## Addendum #02

**PROJECT:** Coit Arts Academy – Phase 2 Summer 2025 Work  
617 Coit Ave NE  
Grand Rapids, MI 49506

**Addendum No.** 02

## Addendum # 2

A-101B.2

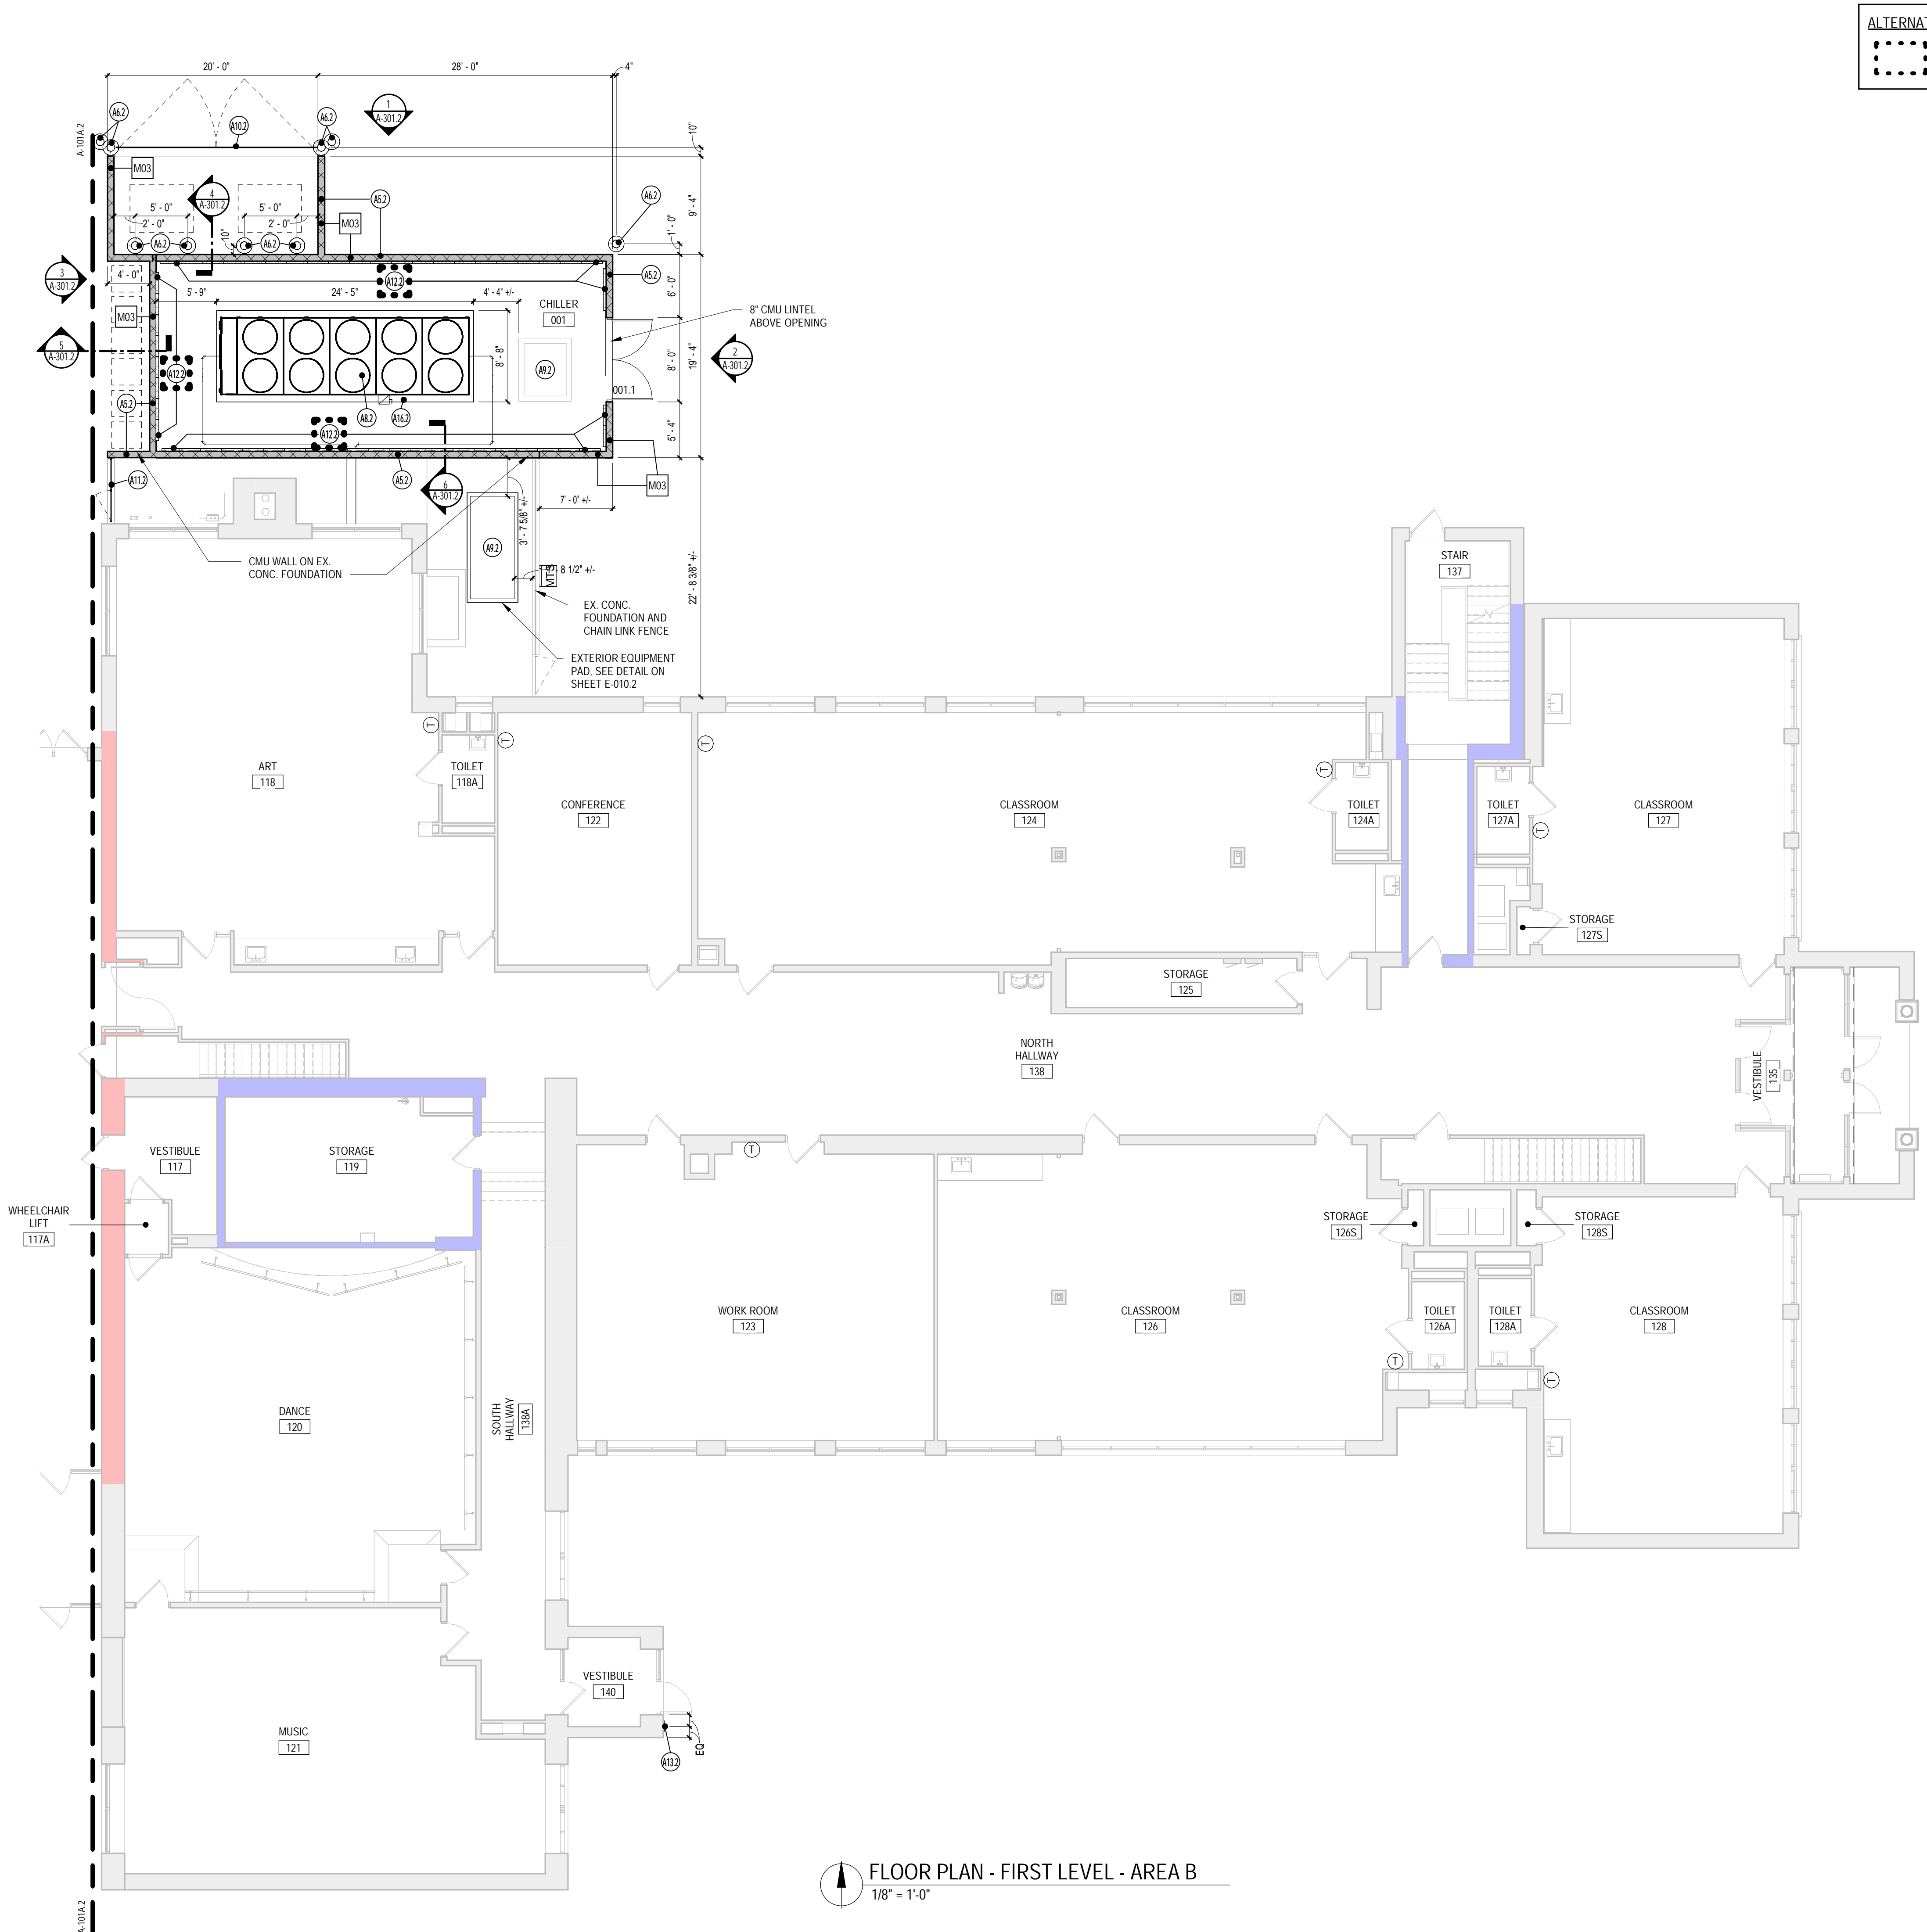
- A2.15 Refer to Sheet A-101B.2 (reissued):  
Revise Keynote A5.2 to read, "8" CMU WALL WITH SOLID CMU CAP. INTERIOR OF CHILLER WALLS TO BE LINED WITH ACOUSTIC PANELING (SEE ALTERNATES)."

KEY VALUE	KEYNOTE TEXT
A5.2	CMU WALL WITH SOLID CMU CAP. INTERIOR OF CHILLER WALLS TO BE LINED WITH ACOUSTIC PANELING (SEE ALTERNATES).
A6.2	STEEL BOLLARD.
A8.2	MECHANICAL EQUIPMENT.
A9.2	ELECTRICAL EQUIPMENT.
A10.2	CHAIN LINK SWING GATE W/ PRIVACY SLATS.
A11.2	CHAIN LINK FENCE WITH MAN GATE.
A12.2	EXTERIOR ACOUSTIC PANEL.
A13.2	SALVAGED DOOR SIGNAGE. INSTALL 60" ABOVE FINISH FLOOR.
A16.2	EXTERIOR EQUIPMENT PAD FOR CHILLER. SEE DETAIL ON E-010.2.
